STAFF RECOMMENDATION

203 N 18th Street

May 20, 2020

Application: New Construction—Infill

Figure 3. Site plan showing irregular lot and proposed footprint

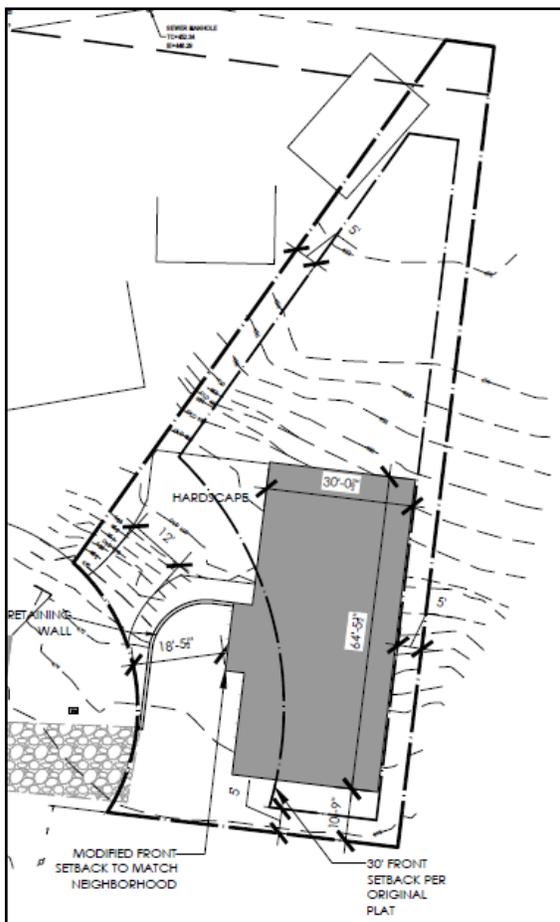
The front elevation is about sixty-four feet, five inches (64'5") wide. The historic context nearby on Forrest Avenue includes houses that range from about twenty-one to thirty-six feet (21'-36') wide. This house is nearly twice as wide as the closest historic context; however, due to the shape of the lot – and the lack of an immediate historic context - a somewhat wider house may be appropriate in this location. (Figure 3)

The front setback is proposed at about eighteen feet five inches (18'5") from the front property line. This is roughly similar to the front setback of the house next door at 204 N

18th Street. On the north, east and south sides, the house will sit at least five feet (5') from the property lines.

The application uses one curb cut for a shared driveway, which is appropriate. However, the driveway terminates in front of Unit A, creating front-yard parking, which the guidelines state is not consistent with the character of the historic neighborhoods. Staff recommends that the driveway extend to the north side of the duplex so that parking occurs on the side/rear, rather than in the front.

Staff finds that the proposed setbacks and rhythm of spacing to meet Section II.B.3. of the design guidelines.

5. The driveway shall be extended to the north side of the house to eliminate front-yard parking; and
6. The HVAC be located behind the house or on either side, beyond the mid-point of the house;

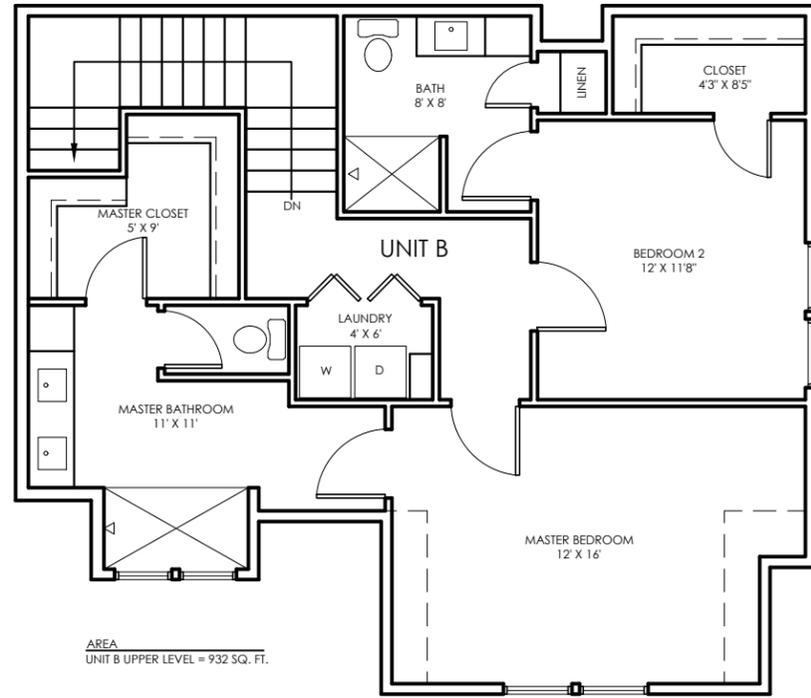
The proposed infill has a maximum height of about 26' (twenty- six feet) from grade at the highest point of the slope, and about thirty-three feet (33') high from the steepest point of grade. Nearby historic houses on Forrest Avenue on comparably sized lots are between about twenty-two to twenty-nine feet (22'-29') tall. Staff finds that, given the slope, the proposed infill could be appropriate in terms of height.

The design includes a substantial brick foundation. While the foundation will necessarily gain height as the grade drops away, the foundation height on Unit B extends up to just below the first floor windows. Staff recommends lowering the brick on Unit B to approximately the finished floor line.

The house uses a cross-gabled roof form with a 12/12 slope. This roof form is seen throughout the overlay and is consistent with the historic context. There is a dormer on each unit. The guidelines require that the front wall of the dormers be inset two feet (2') from the main wall below; however, the drawings are unclear so staff recommends final review of the dormer locations.

The house will be oriented on axis with N 18th Street. Staff finds this to be appropriate, though staff would also support angling the house slightly to be oriented to the cul-de-sac, thus enabling the design to take advantage of the depth of the lot. The house will have a partial-width covered front porch. The porch is six feet (6') deep. There is a walkway from the front door to the street. Unit A does not have a porch. Staff recommends that a hood be added in this location, as would often be seen on historic secondary entrances.

With the condition that the front dormers be inset two feet (2') from the wall below, staff finds that the proposed roof form meets Section II.B.5. of the design guidelines.

Staff finds that with the addition of a hood to the entry of Unit A and with the extension of the driveway to the north side of the duplex, the infill's orientation will meet Section II.B.6. of the design guidelines.
